## **Febeliec answer to the Elia public consultation on the scenarios, sensitivities and data for the CRM parameter calculation for the Y-4 Auction for Delivery Period 2025-2026 on the input data for the adequacy and flexibility study 2019**

### **Febeliec comments to the explanatory note from Elia.**

Figure 1: Belgian electricity demand 2000-2019 (source: Elia, received 27/05/2020)

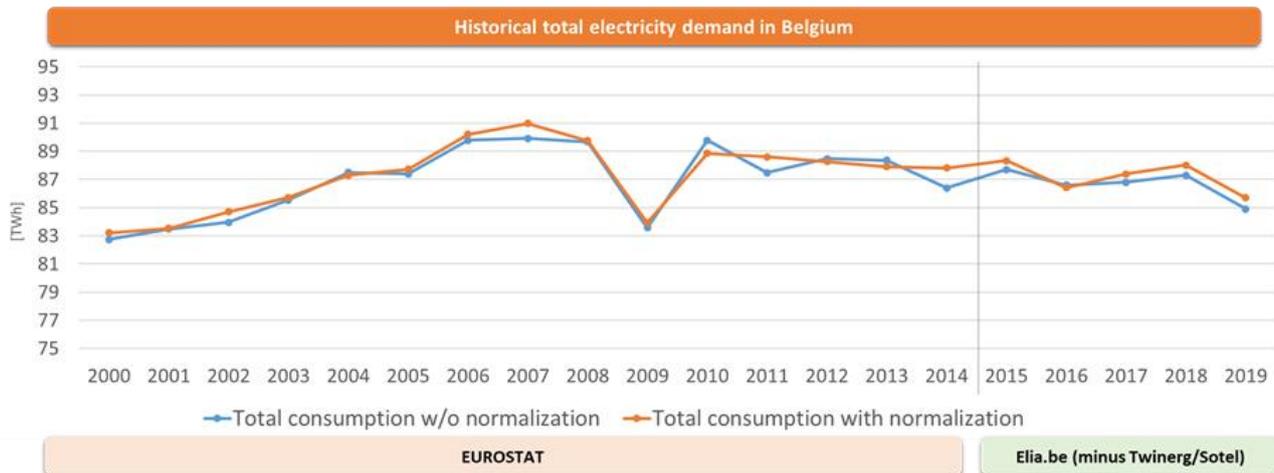
On consumption (or demand, as the terminology is in the spreadsheet), Febeliec is even more concerned. Not only is it unclear on which basis this demand is determined. Elia is referring to the latest forecast from the final (yet not approved by the European Commission) National Energy and Climate Plan (NECP), which was published end of 2019, based on additional measures. However, and as already commented by Febeliec and not yet taken into account by Elia, as of 2020 the world has entered in presumably the worst global economic crisis in over a century (Covid-19 crisis), with definitely a major impact on electricity demand in the short term (Elia itself presenting values that drop up to 25% at some points) and which presumably will also continue to wreak havoc in future years, both in the level of growth (or lack thereof) as well as the starting point for the growth curve (if the crisis indeed severely impacts the basis of the economic tissue of the world economy). Elia for example states that "*there is an increase in the numbers between the draft and the final NECP (WAM scenario) which is mainly due to additional industrial consumption in Flanders considered by the authorities*", which should at least also include an assessment of the additional generation capacities linked to these projects. Febeliec in this context wants to refer to data that was provided by Elia on Belgian overall electricity demand in the period 2000-2019 (both non-normalised and normalised data).

As can be seen from this data, the 2008 financial crisis, which was the major economic crisis in the current millennium with substantial global economic impact, shows a clear drop of more than 6TWh (or around 7% of Belgian consumption) in the wake of this crisis. A decade later, Belgian electricity demand has still not regained pre-2008 levels (with a.o. 2019 showing even a continued decrease in overall demand, reaching a level that was last seen in 2002, despite a substantial increase in Belgian GDP over that period). While the underlying reasons for this observation are beyond the scope of this consultation (e.g. impact of energy-intensity of GDP-growth, impact of energy-efficiency measures, ...), the trend can be clearly observed. Important in the light of the current covid-19 crisis, which will presumably have a much more pronounced effect on the global economy, is that it would be imprudent to not take into account such impact on Belgian electricity demand, also when looking at 2025 and beyond. Febeliec asks that at the very least additional sensitivities are included (see below) in case this impact would not be considered in the central reference scenario, and this in particular to avoid that the analysis would indicate a potential need for a CRM, based on outdated data sets, leading to a very costly<sup>1</sup> yet unnecessary subsidy scheme to be financed by consumers.

- On the NECP Low Demand sensitivity, Febeliec has no comments as such, except that this is based on the NECP published end of 2019, in pre-covid-19 times. Febeliec refers to its abovementioned comments on the impact of covid-19; according to Febeliec it would be unrealistic to imagine that covid-19 would not have any effect on Belgian electricity demand in light of the unprecedented drop in global economic activity in recent times and in light of Elia’s own public statements and data on the more than substantial drop in electricity demand in the recent months<sup>2</sup>. As can be seen from the Belgian electricity demand data 2000-2019 provided by Elia

(with very little fundamental differences between normalised and non-normalised data, other than that in the data set normalised data on average slightly overestimates real electricity demand), electricity demand dropped very sharply in the aftermath of the 2008 financial crisis (minus 6 TWh or around 7%), which showed a less pronounced reduction in economic activity than can now already be observed by the non-ended covid-19 crisis, with a recovery afterwards that still has not reached in 2019 the pre-2008 level (still more than 3,5 TWh down compared to 2008 levels). Febeliec would thus propose to add two times two new sensitivities. A first additional sensitivity set could be to take the impact of the 2008 financial crisis as a proxy (so a drop of 6TWh in overall Belgian electricity demand based on the provided demand data from Elia) and then have two variations on this, one with a V-shaped recovery (as after the financial crisis of 2008, yet also there with even a decade later still electricity demand levels that are several percent lower) and one with a much slower recovery (to mimic a second wave of covid-19 or other effects that could generate additional damage to the economic tissue, with increased ripple-through effects in 2025 and beyond). A second sensitivity set would then contain two similar sensitivities, but based on a much more pronounced drop in electricity demand in 2020 (e.g. -10 TWh). Febeliec proposes these four additional sensitivities as the current proposed sensitivity based on the NECP of end 2019 does not take into account any scenario with a decrease in electricity demand, a scenario that in any case should be analysed unless one would to consider the covid-19 crisis as irrelevant.
